Service Bulletin

Bulletin No.: 19-NA-143

Subject: Loose Fit and/or Rattle Type Noise Heard From the Liftgate Sill Garnish Molding/
Accessory Illuminated Sill Plate

5169891

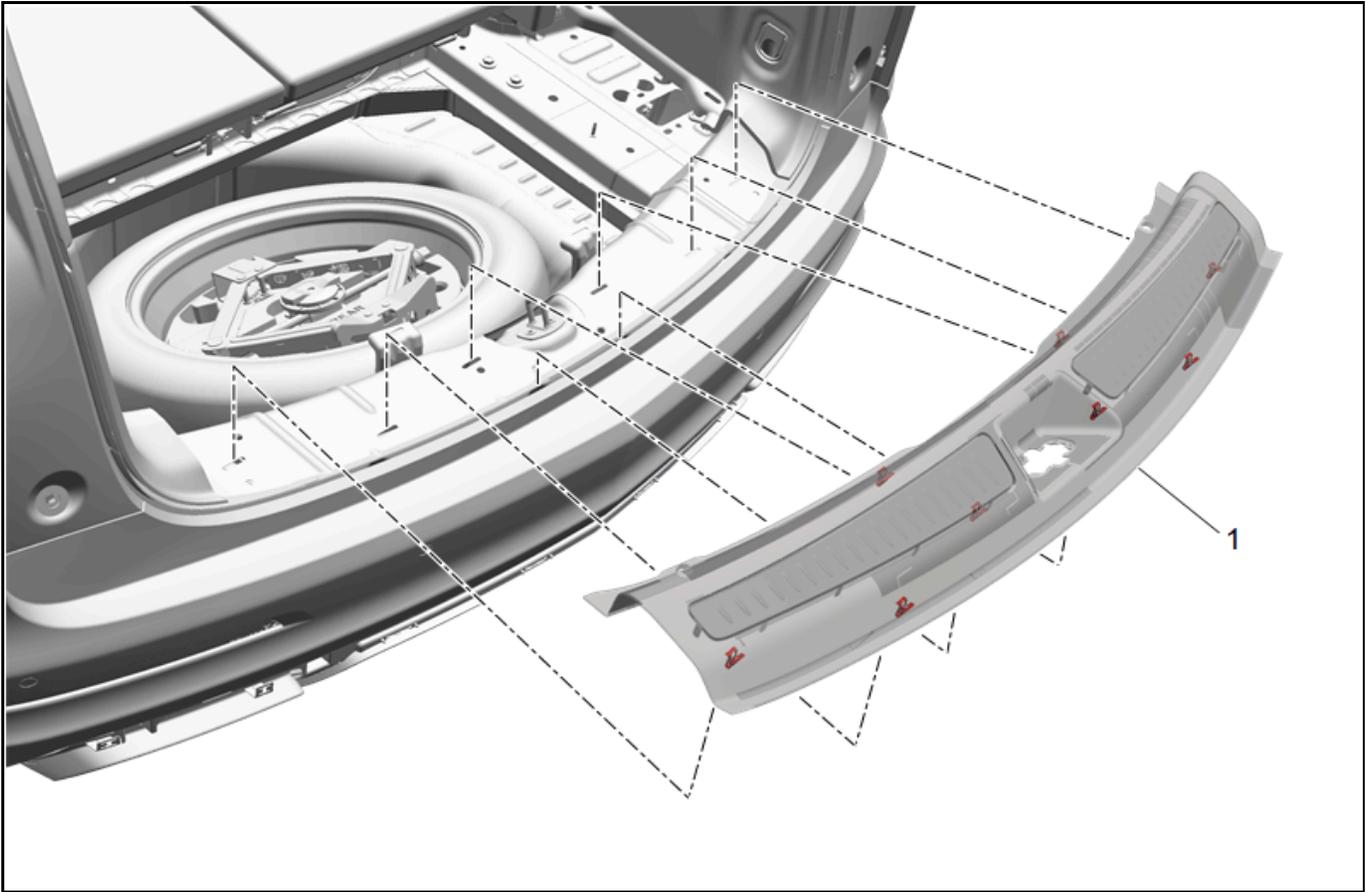
5. Install the 8 new retaining clips to the liftgate sill garnish molding.
6. Position the sill plate to the sill of vehicle and engage the clips to the rear sill.
